HUNTS POINT INTERSTATE ACCESS IMPROVEMENT PROJECT – CONTRACT 3

PIN X731.65, Contract D900055

Request for Proposals

Addendum #2

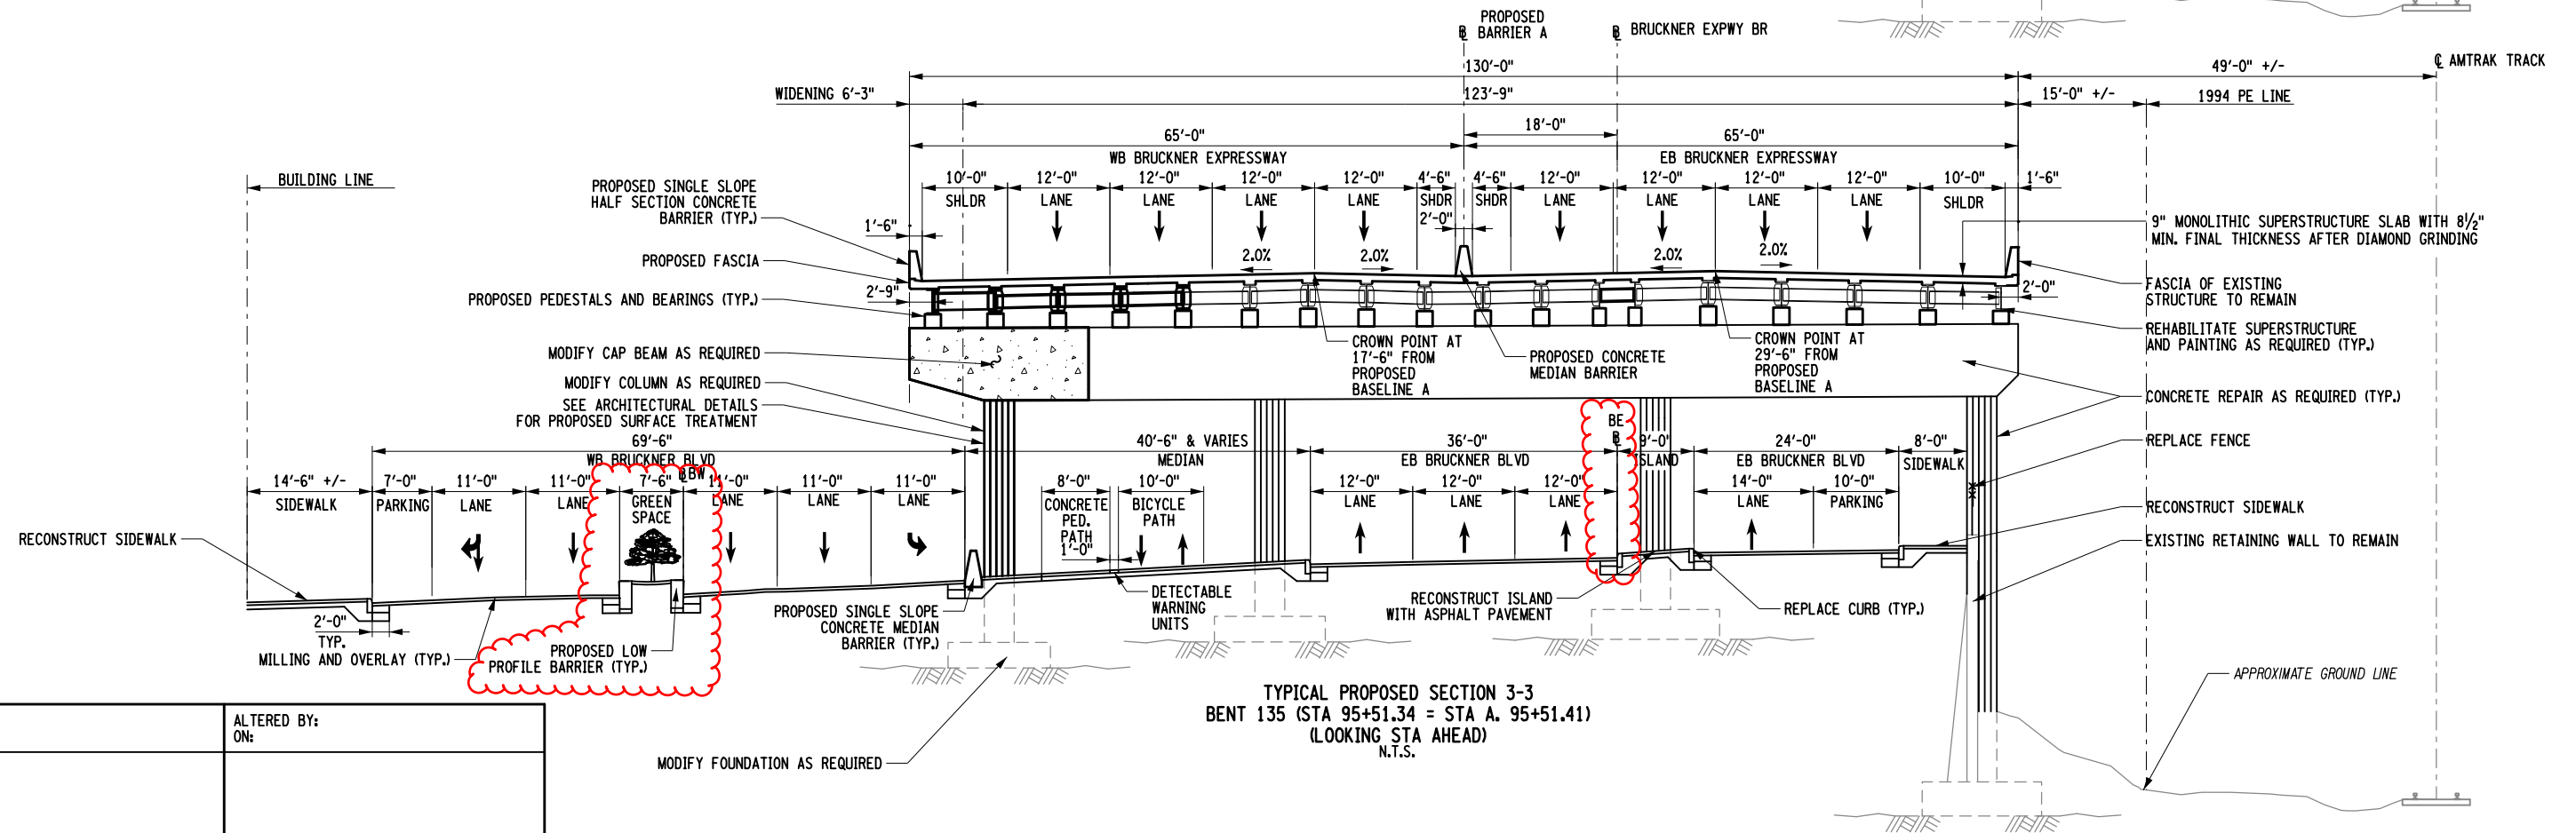
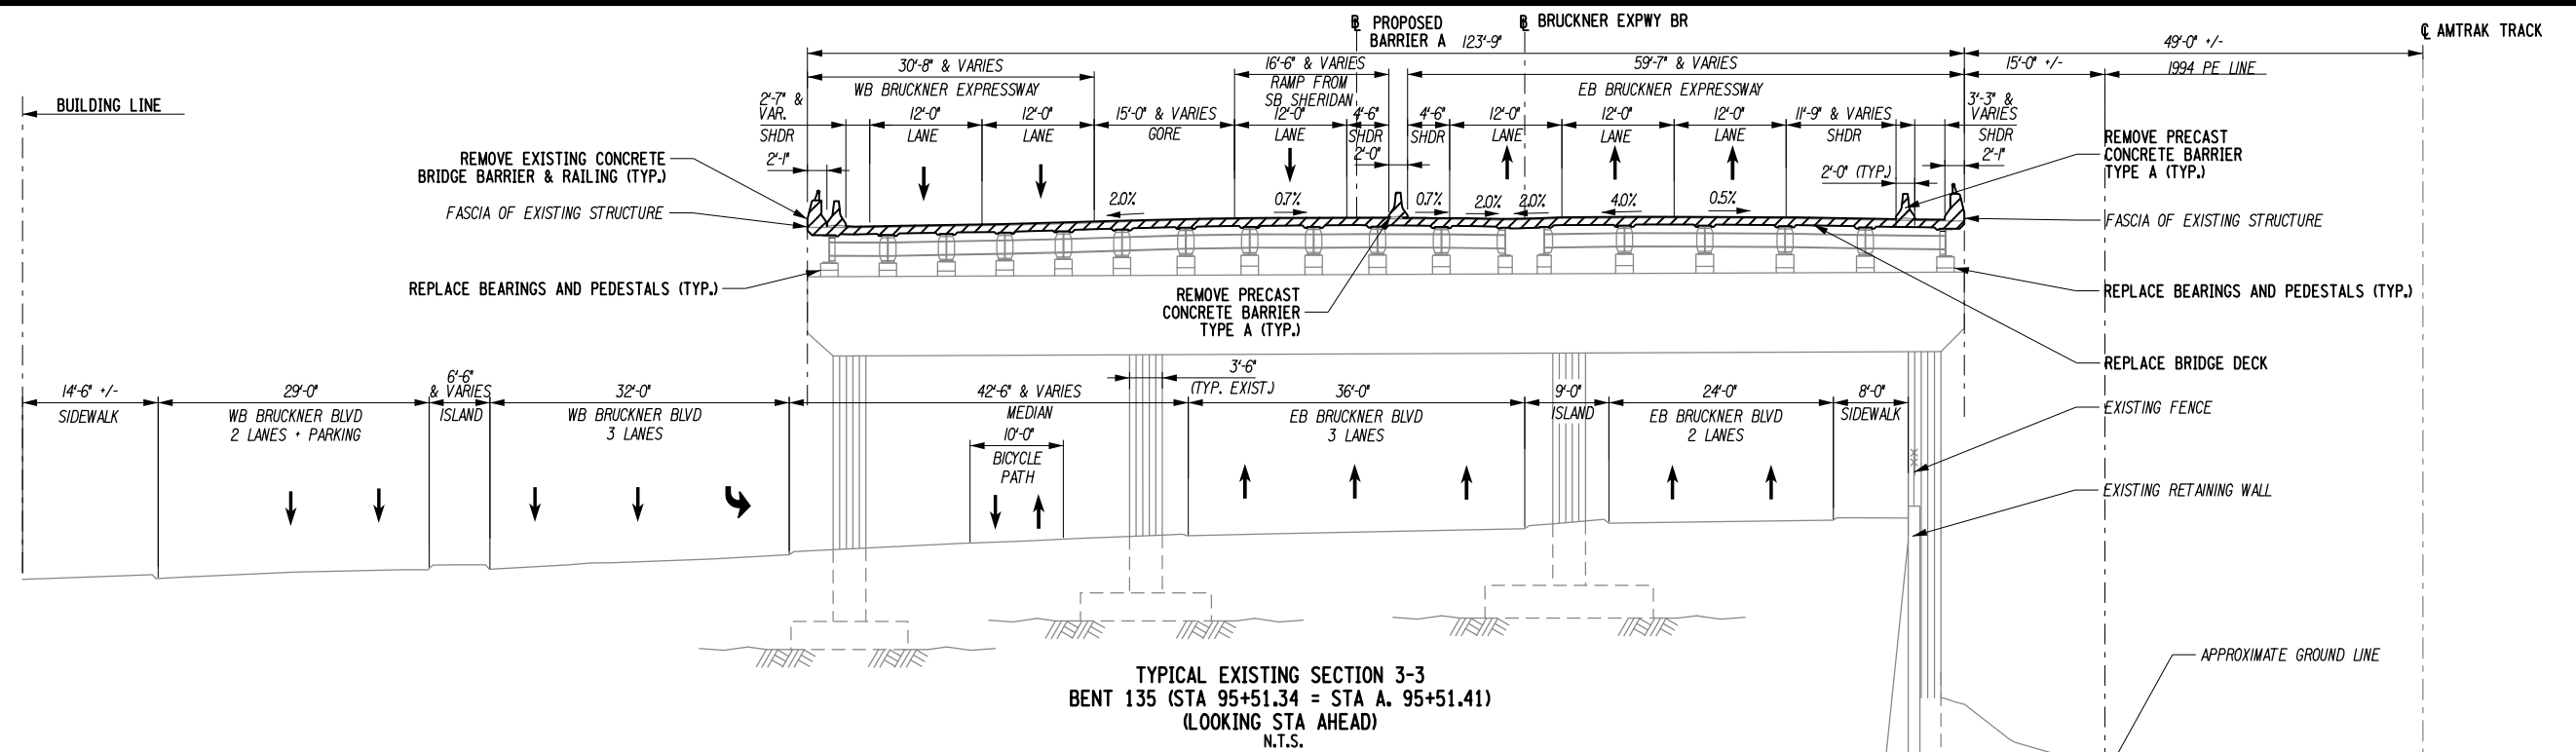
- BE and BW baselines added
- Low profile barrier added

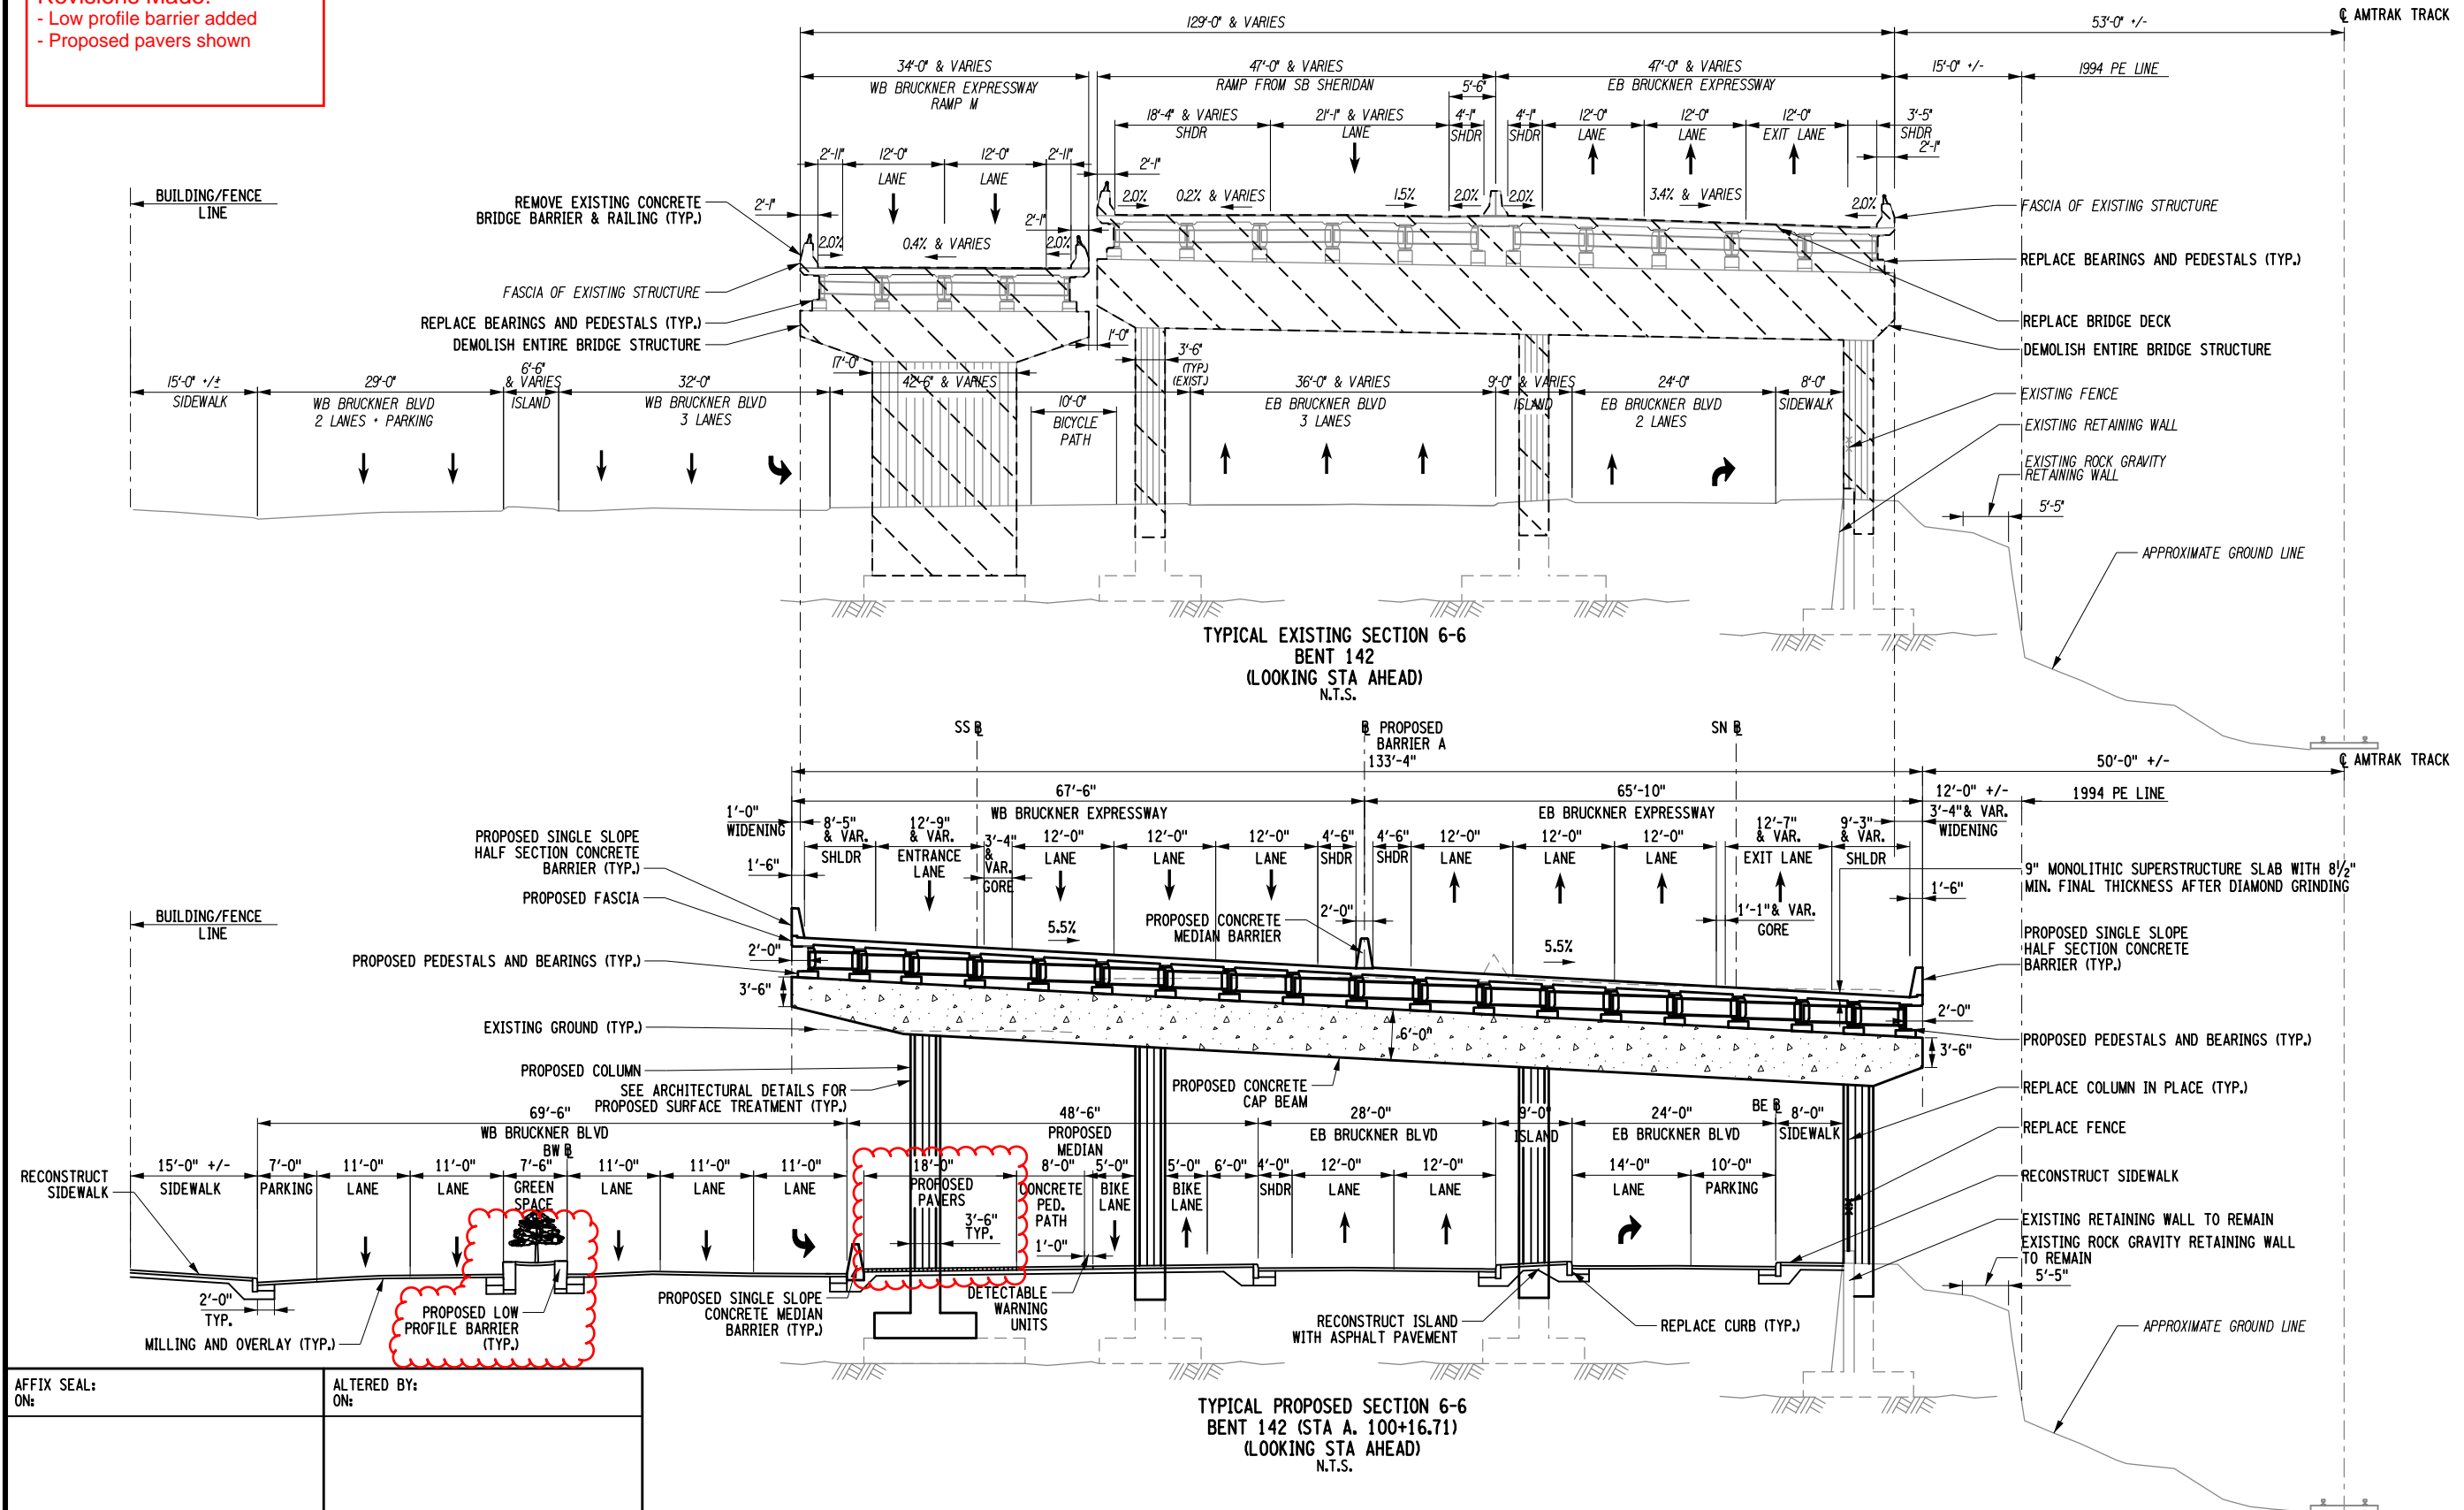
- Low profile barrier added
- Proposed pavers shown

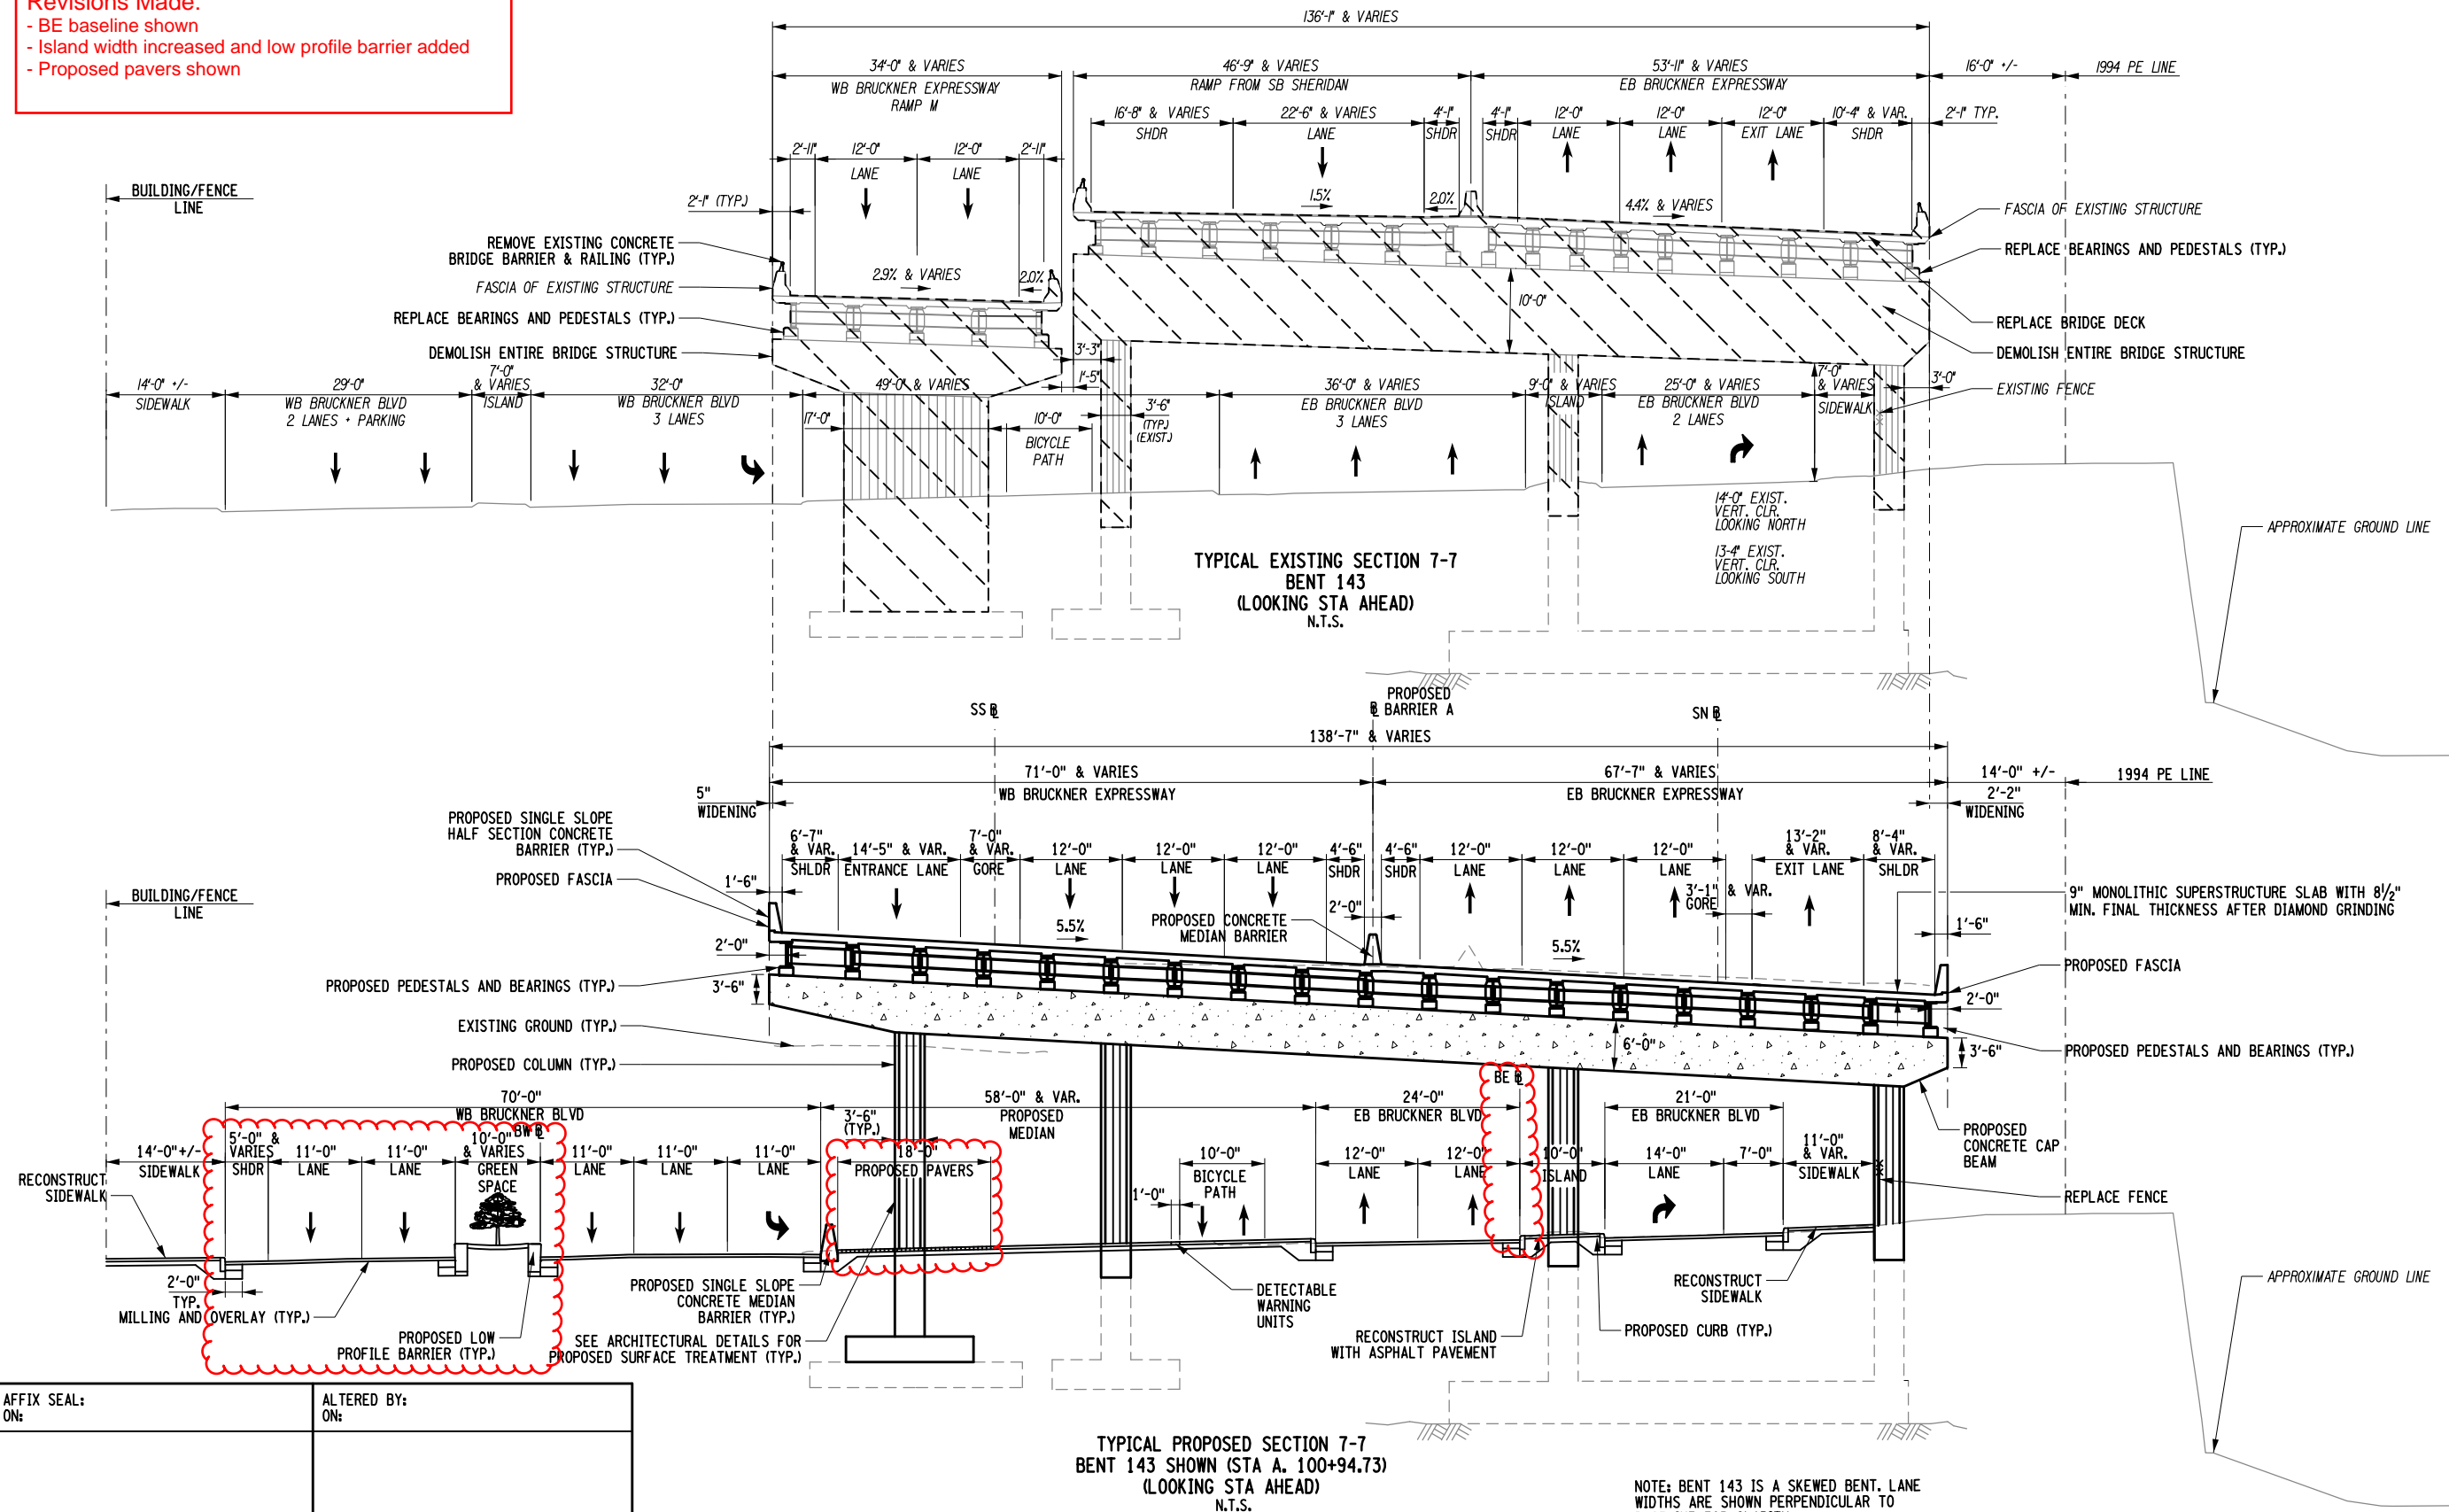
- BE baseline shown
- Island width increased and low profile barrier added
- Proposed pavers shown
